Technical Service Bulletin

**CLUNKING NOISE FROM FRONT SUSPENSION WHEN DRIVING
OVER BUMPS**

Bulletin No.: 02-012/18

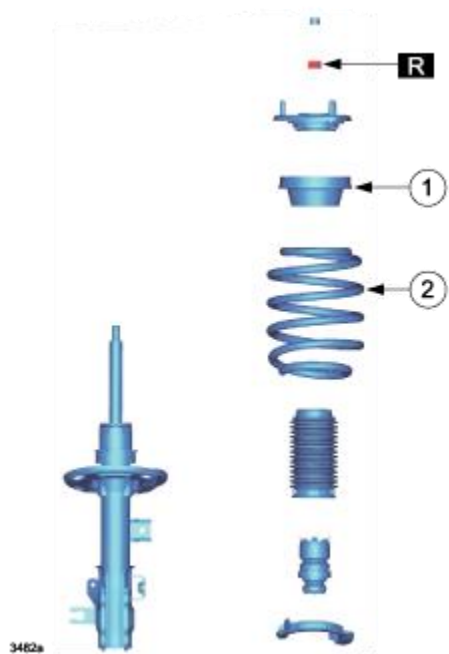
Some vehicles may exhibit a clunking noise from the front coil springs when driving over bumps. The noise is due to stick-slip between the front strut bearing (1) and the coil spring (2).

To eliminate the noise, protectors have been installed onto the coil spring.

Mounting Rubber Removal Note:

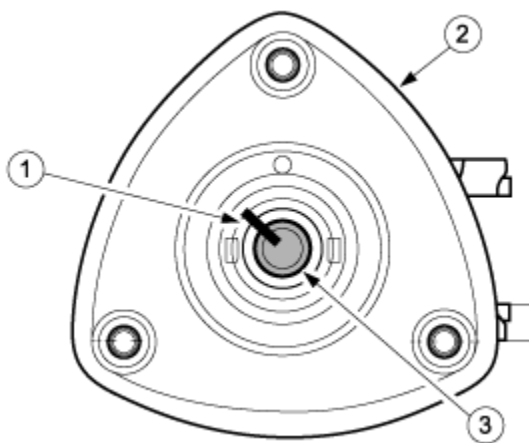
Place a position mark (1) on the mounting rubber (2) and piston rod (3) before removing the mounting rubber from the shock absorber assembly, so the mounting rubber can be reinstalled back to its original position. If this is done, it is not necessary to adjust the front wheel alignment because the front shock absorber and mounting rubber are not replaced.

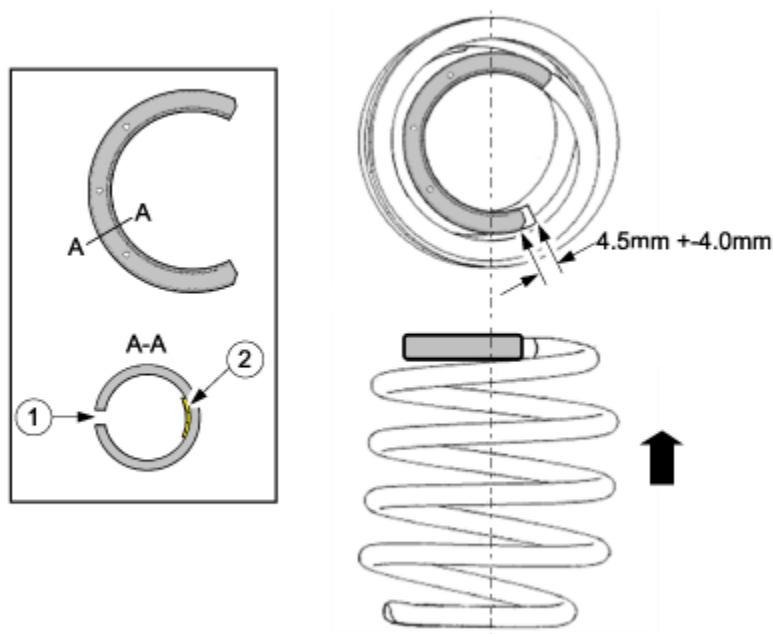
3. Degrease one turn of the coil spring starting from the top.
4. Install the protector onto the coil spring. Align the end of the protector with the position of the coil spring, as shown below.

NOTE: Install the protector so the gap (1) is positioned as shown below, 4.5 +/- 4.0mm (0.177 +/- 0.157 in) from the end of the spring.

5. The inner side of the protector contains adhesive glue (2). After the installation, press on the protector to adhere it to the coil spring.
